REMARKS – General

The Objection To The Specification And The Claims Rejection Under Section 112

DRAWINGS:

Fig. 1A – Main embodiment, a waste heat recycling thermal power plant.

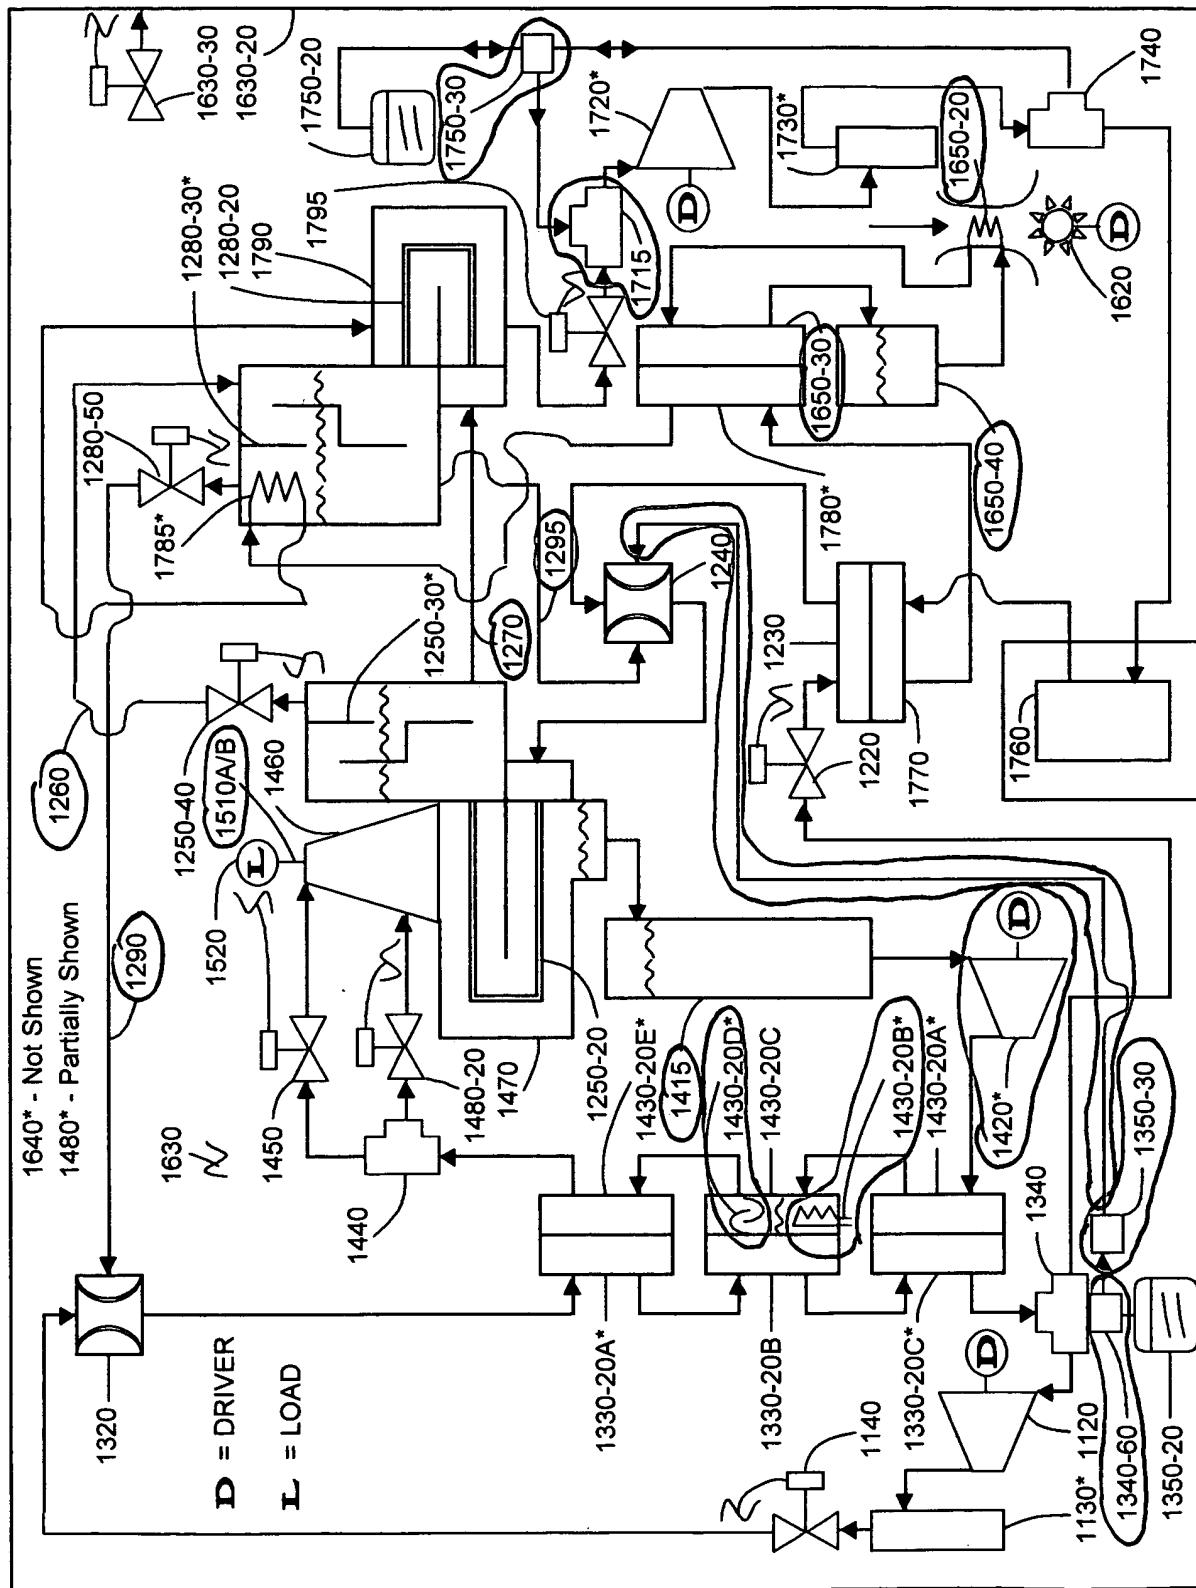
Fig. 1A is an electronically drafted rendition of the manually produced drawing originally submitted to illustrate the features of the main embodiment. Figs. 1B through 1H are similarly produced, and each concentrates on illustrating the features of a single circuit of the main embodiment. Fig. 2A is an electronically drafted rendition of the manually produced drawing originally submitted to illustrate the features of the alternative embodiment. Fig. 2B is similarly produced, illustrates the features of the suction flow circuit of the alternative embodiment. All reference numerals are typed for legibility, and recited on the appropriate drawings. In some instances, items (1260, 1270, 1510A/B, 1650-20, 1650-30, and 1650-40) have been re-numbered and/or renamed, and in one instance an item (1715) recited in the list of reference numerals, but inadvertently omitted from Fig. 1 has been recited graphically on the appropriate amended drawings (Figs. 1A, 1H, and 2A), and textually in the specification. In addition, items (1340-60, 1350-30, 1420*, 1430-20B*, 1430-20D*, and 1640*) recited in the specification, but inadvertently omitted from Fig. 1 have been recited graphically on the appropriate amended drawings (Figs. 1A, 1D, 1E, 1G, and 2A). Conversely, items (1240-15, 1240-35, 1290, 1295, 1415, 1650-30, 1650-40, and 1750-30) recited graphically on the previously submitted drawings, but inadvertently omitted from the specification, have been recited textually, where appropriate, in the specification to aid the reader gain a clearer understanding of the invention.

Page 71, replace with the following new paragraph:

Fig. 2A – Alternative embodiment, a waste heat recycling thermal power plant, with a modified suction flow circuit.

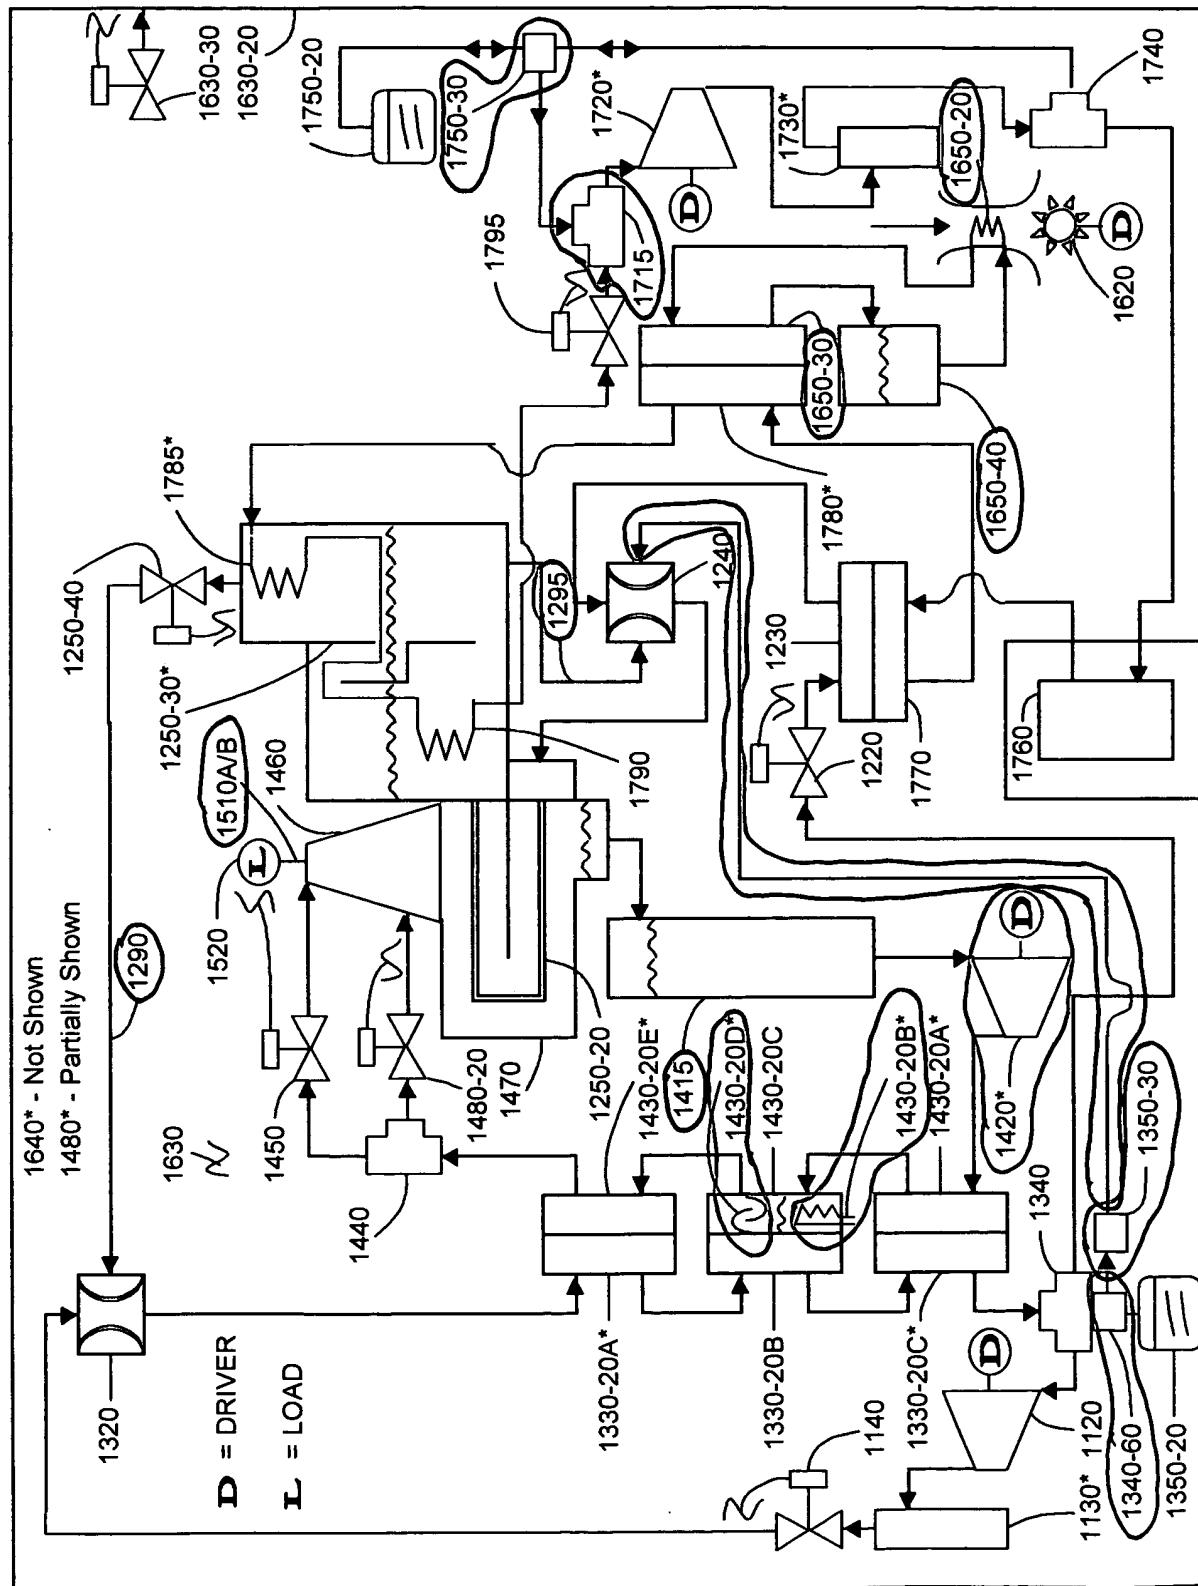
Page 79, replace with the following new paragraph:
